APPLICATION NO.	FILING DATE	FIRST NAMED INVENTOR	ATTORNEY DOCKET NO.	CONFIRMATION NO.
10/658,639	09/09/2003	Han-Lim Lee	5000-1-433	4713
33942	7590	02/19/2008	EXAMINER	
CHA & REITER, LLC			LIU, LI	
210 ROUTE 4 EAST STE 103				
PARAMUS, NJ 07652			ART UNIT	PAPER NUMBER
			2613	
			MAIL DATE	DELIVERY MODE
			02/19/2008	PAPER

Office Action Summary	Application No.	Applicant(s)	
	10/658,639	LEE ET AL.	
	Examiner	Art Unit	
	Li Liu	2613

DETAILED ACTION

Figure O1

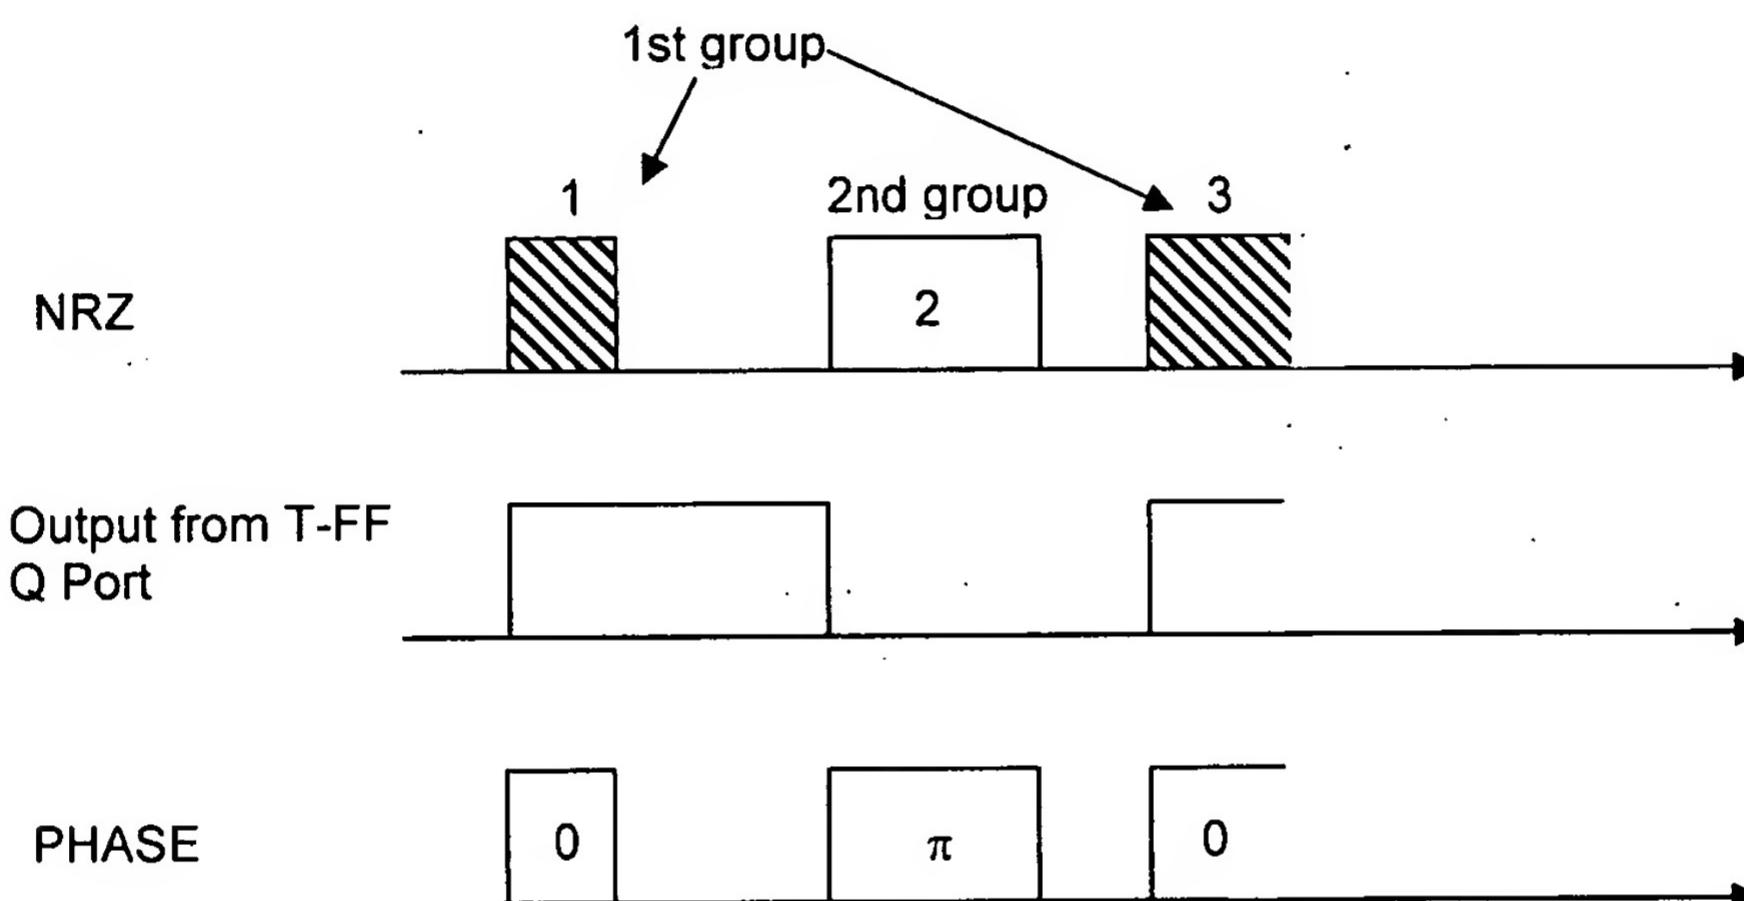
As disclosed by Kitajima et al and Wei et al, the T flip-flop is triggered in response to a rise-up edge of the input signal to thereby produce an output signal (e.g., at one output) having a waveform such as illustrated in following Figure O1 (the Output from T-FF Q Port), this electrical signal separates "1" bit values in the sequence of the

NRZ electrical signal into first groups of "1" bit values (e.g., the group of "1" at the odd position) and second groups of "1" bit values (e.g., the group of "1" at the even position).

The first group of "1" is "represented/drived" by the electrical signal with intensity of "1" in the output of T-FF Q-Port, the second group of "1" is "represented/drived" by the electrical signal with intensity of "0" in the output of T-FF Q-Port.

output 17-a in Figure 8A), for separating by received “1” bit values of the inputted NRZ electrical signal into first (see Figure O1, the shaded “1”, e.g., shown in positions 1 and 3) and second groups (see Figure O1, the un-shaded “1”, e.g., shown in position 2).

in view of Kitajima et al and Kaiser et al discloses wherein the first group of '1' in the sequence and the second group of '1' in the sequence have been separated from the NRZ electrical signal, respectively (Ref to Figure O1).

As shown in Figure O1, Kitijma et al and Wei et al teaches that the T-flip-flop separating by received "1" bit values of the inputted NRZ electrical signal into first (see Figure O1, the shaded "1", e.g., shown in positions 1 and 3) and second groups (see Figure O1, the un-shaded "1", e.g., shown in position 2), that is, the group of '1' in odd positions in the sequence and the group of '1' in even positions in the sequence are separated from the NRZ electrical signal, respectively; and first group of "1" is "represented" by the electrical signal with intensity of "1" in the output of T-FF Q-Port, the second group of "1" is "represented" by the electrical signal with intensity of "0" in the output of T-FF Q-Port. And Ono et al also teaches that the phase of the output signal from the duobinary modulators depends on the drive signal from the precoder and the phase different is ' π ' (column 7, line 10-13, the LN optical phase modulator modulates the optical phase into π or 0 according to the value, 1 or 0, of an electrical signal to be input). And Wei et al teaches to use the output from the T-FF to drive the phase modulator. Refer to Figure O1, the drive signal for the first group is different from the drive signal for second group, therefore, it would be obvious that the first group of

'1' in the sequence and the second group of '1' in the sequence have a phase difference of ' π ' with respect to each other.
